WATER SYSTEM STANDARDS

**STATE OF HAWAII
2002**

Amendments to the 2002 Water System Standards

BOARD OF WATER SUPPLY

**COPPER SERVICE LATERAL
FOR CONNECTION TYPE III METER BOX
1 1/2" & 2" METERS
SCALE: NTS**

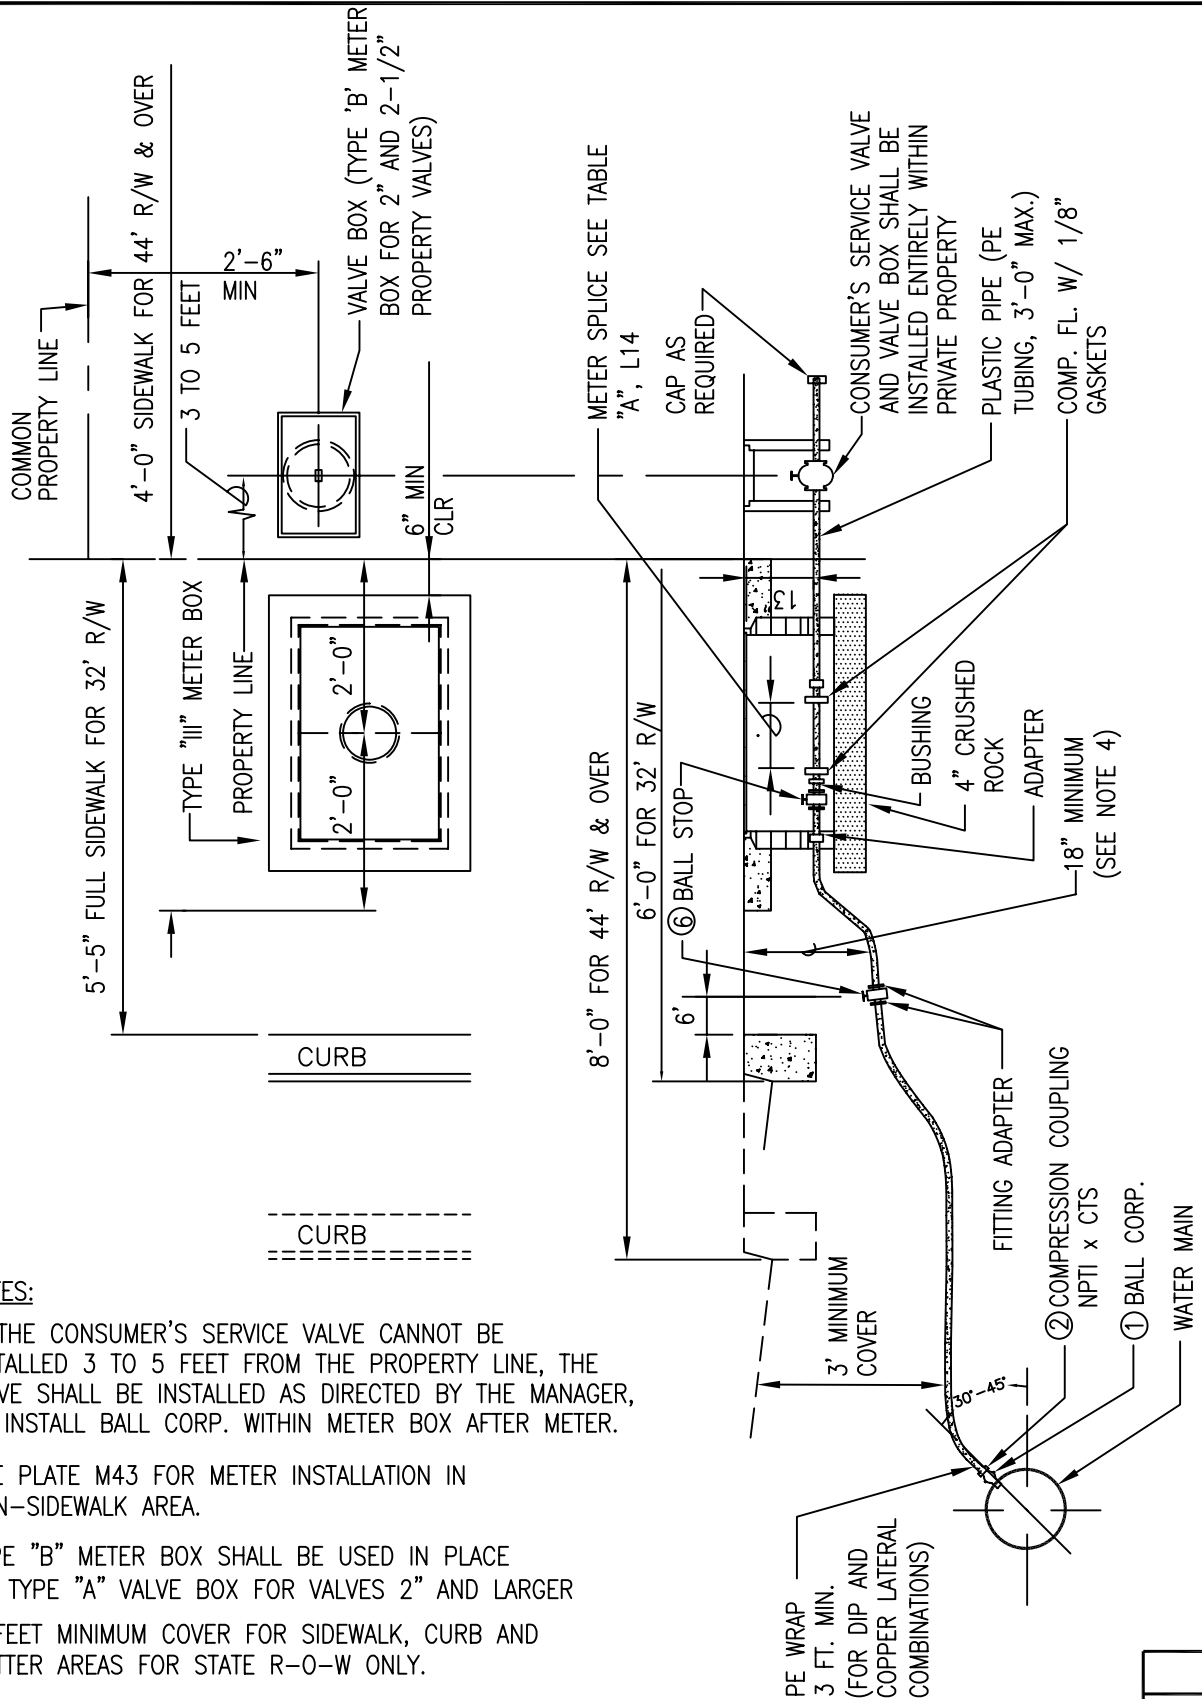
<u>Standard Detail</u>	<u>Description</u>
L13	Copper Service Lateral for Connection Type "X" Meter Box 5/8", 3/4", & 1" Meters
L15	Copper Service Lateral for Connection Type III Meter Box 1-1/2" & 2" Meters
L20	Typical Detail for Installation of Ball Stop After Meter
L21	New Lateral Installation Schematic Detail
L22	Lateral Reconnection Schematic Detail

1. IF THE CONSUMER'S SERVICE VALVE CANNOT BE INSTALLED 3 TO 5 FEET FROM THE PROPERTY LINE, THE VALVE SHALL BE INSTALLED AS DIRECTED BY THE MANAGER, OR INSTALL BALL CORP. WITHIN METER BOX AFTER METER.
2. SEE PLATE M43 FOR METER INSTALLATION IN NON-SIDEWALK AREA.
3. TYPE "B" METER BOX SHALL BE USED IN PLACE OF TYPE "A" VALVE BOX FOR VALVES 2" AND LARGER
4. 3 FEET MINIMUM COVER FOR SIDEWALK, CURB AND GUTTER AREAS FOR STATE R-O-W ONLY.
5. SEE PLATE L17 FOR MATERIAL SCHEDULE.

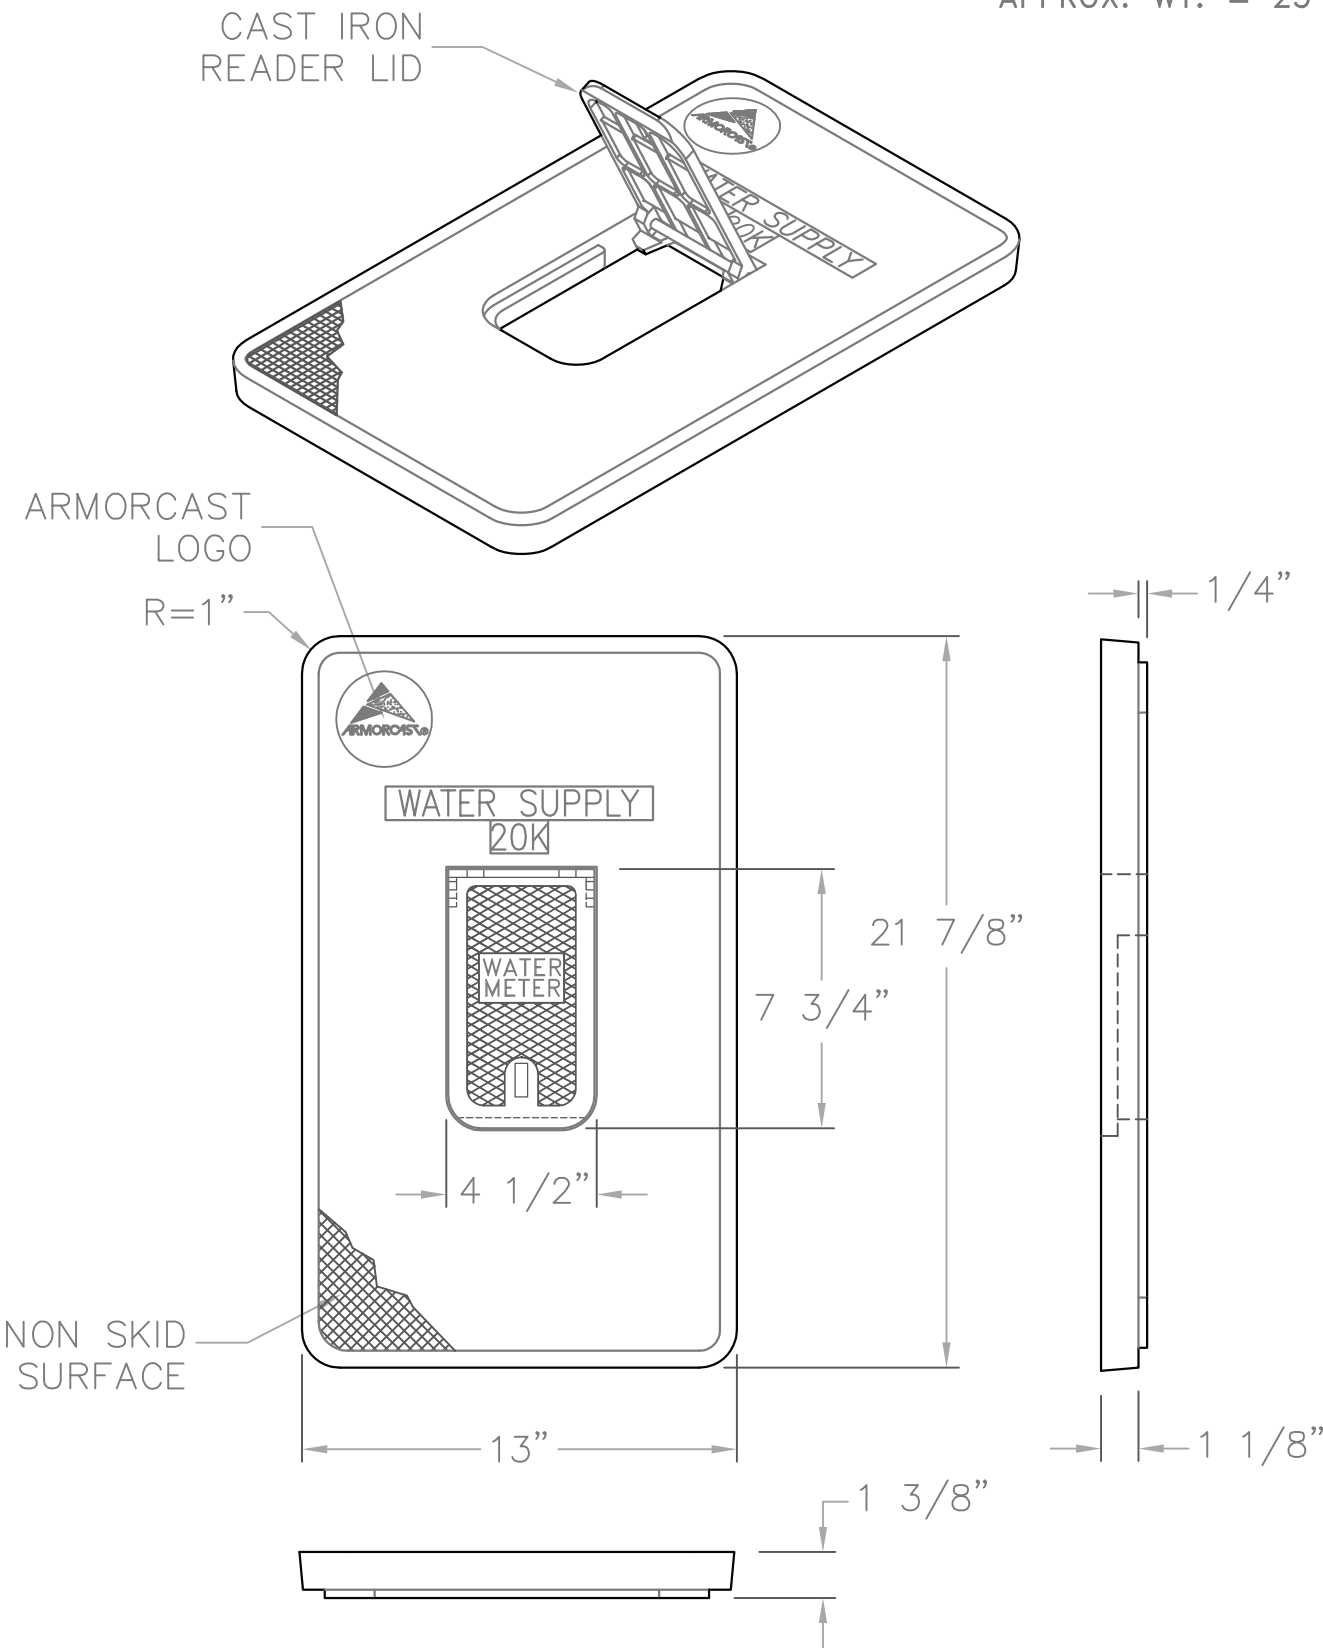
Effective immediately for Oahu only, all Polymer Concrete Type X Meter Box
Covers shall be furnished with a cast iron reader lid as shown on the enclosed
Drawing No. A6001869TRCI.
